Re: Bishop Tube 2019 Remedial Investigation Report and Feasibility Study

Subject: Comments on the Bishop Tube 2019 Remedial Investigation Report and Feasibility Study Report

Figure 1: Concentration map for TCE prepared by Baker 2003).

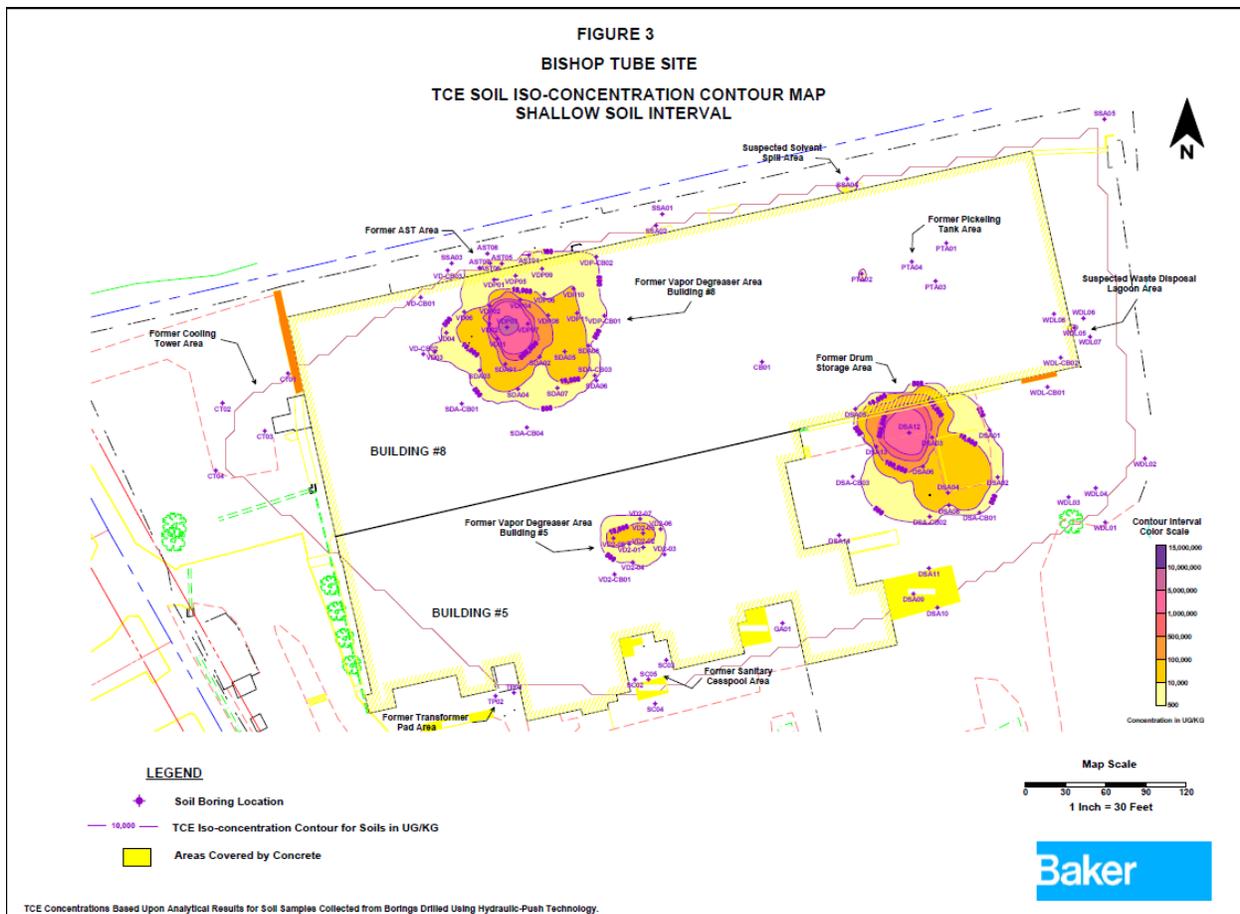
RIR Appendix A compiles soil contaminant masses from 1988 through 2018, but Roux does not analyze soils contaminant concentrations or consider them as a source. It presents figures of concentration in soils by well of TCE and other contaminants including heavy metals; the figures color code wells by contamination categories. Soil samples have identified CVOCs including TCE, 1,1,1-trichloroethane (TCA), cis-1,2-dichloroethene (cDCE), and tetrachloroethene (PCE) (Id.). An earlier figure presented by Baker includes contours of TCE (Figure 1). Contaminants occur in at least three hot spots, but there is no evidence of how they vary with time. Neither the RIR figures nor Appendix A present data that can be analyzed for trend because samples are spot measures, not monitoring points, meaning they extract soil at distinct locations rather than measure concentrations in place.

- The RIR should develop concentration contours for the hot spots for as many points in time as possible. This would create a time series of mass in the soil and provide an assessment of how much of the contaminants degrade or leach into the groundwater with time.
- Roux should sample soils as part of this RIR and provide a current estimate of contaminant mass at each hot spot.
